MONTGOMERY COUNTY HISTORIC PRESERVATION COMMISSION
STAFF REPORT

Address:	9 Chevy Chase Circle, Chevy Chase	Meeting Date:	6/26/2024
Resource:	Master Plan Site #35/13-001A Newlands-Corby Mansion	Report Date:	6/18/2024
Applicant:	Gibson Homes LLC (Patrick Kauffman, agent)	Public Notice:	6/12/2024
Review:	HAWP	Tax Credit:	No
Case Number:	1072452	Staff:	Chris Berger
PROPOSAL:	Hardscape alterations

Staff recommends that the HPC **approve with two conditions** the HAWP application with final approval delegated to staff:

Figure 5: The existing, top, and proposed site plan for the terrace. Alterations include extending the terrace 2 feet, 7 inches, and reducing the width of the stairs.

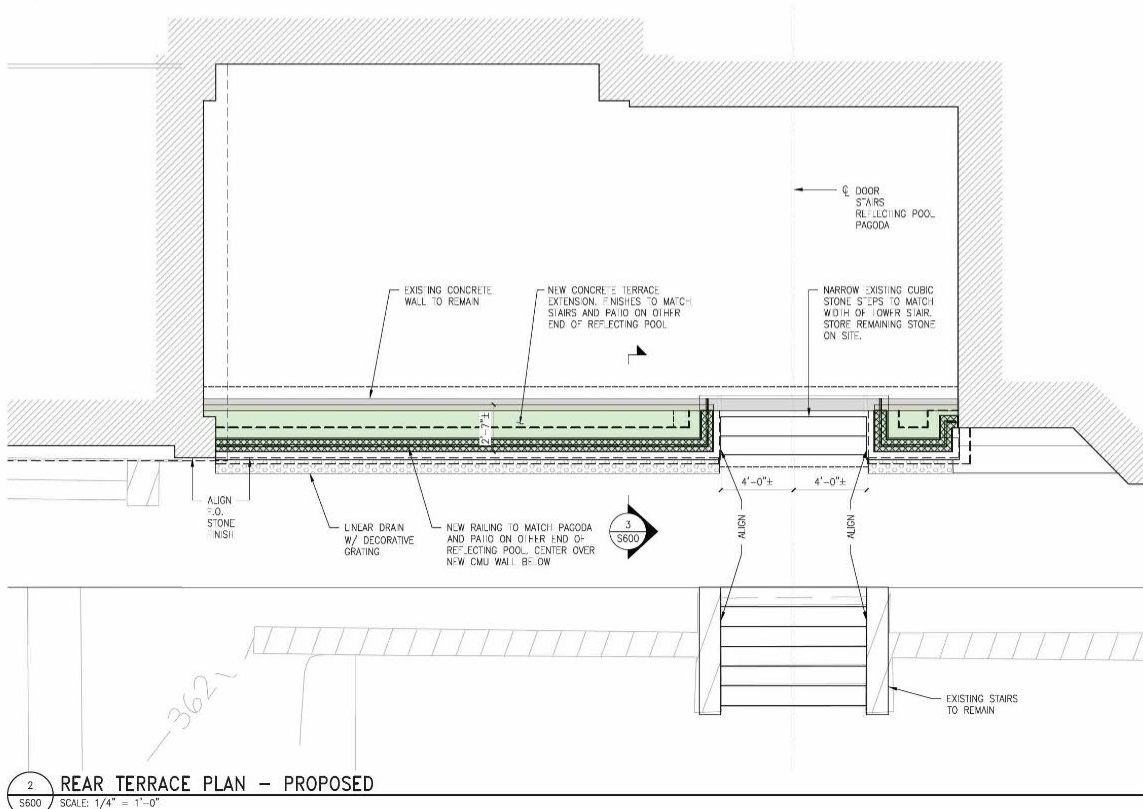
1. The applicant must show the handrails on the plans if they will be installed at the altered stairs. Specifications must be provided if the handrails are different from the existing.
2. Applicant must provide a photo of the pavers on the patio at the opposite end of the reflecting pool as the specification for the pavers to be installed at the expanded terrace.

Staff seeks a condition that the applicant add the handrails to the plans at the narrowed stairs and provide specifications if they differ from the existing handrails. Staff seeks another condition that the applicant provide a photo of the pavers on the patio at the opposite end of the reflecting pool to serve as the specification for the pavers to be installed at the expanded terrace.
